PIC16F684 Rev. A Silicon/Data Sheet Errata

The PIC16F684 parts you have received conform functionally to the Device Data Sheet (DS41202D), except for the anomalies described below.

FIGURE 1: SILICON REVISION A4 VS. REVISION B2

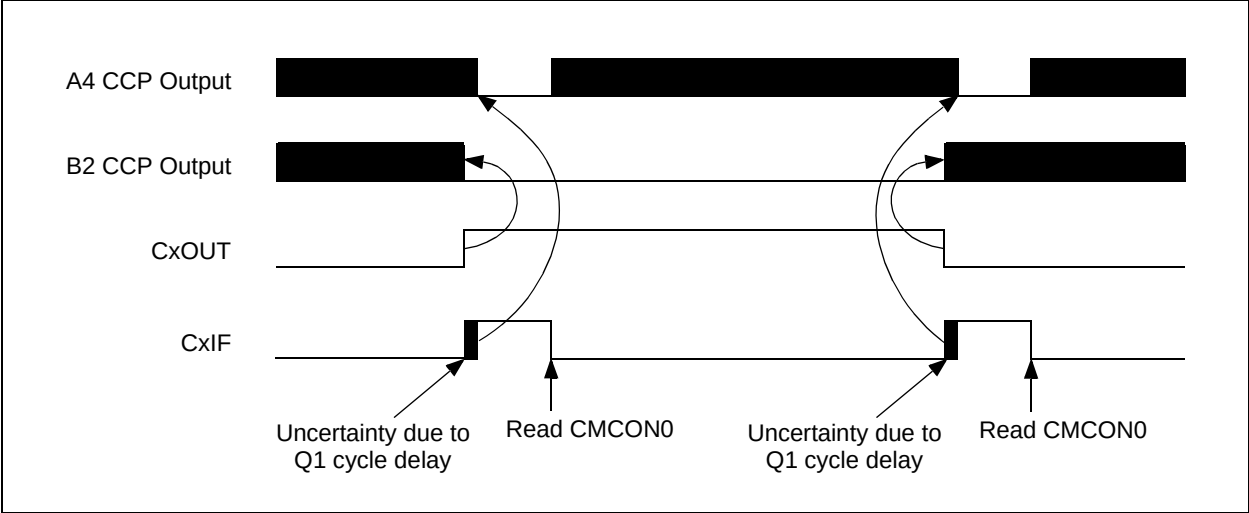
The PIC16F684 Rev. A4 silicon for the ECCP Auto-Shutdown is connected to the C1IF and C2IF flags. See Figures 8-2 and 8-3 on the following page.

Rev. A4's auto-shutdown connection to C1IF and C2IF causes the auto-shutdown to incorrectly operate synchronously. Additionally, reads of CMCON0 will incorrectly clear an auto-shutdown event.

The Silicon Rev. B2 device (now shipping) has moved the auto-shutdown connection from CxIF to CxOUT. This will eliminate the synchronous shutdown and simplify the use of the comparator for a shutdown event. Figure 1 shows the function of auto-shutdown before and after the device revision.
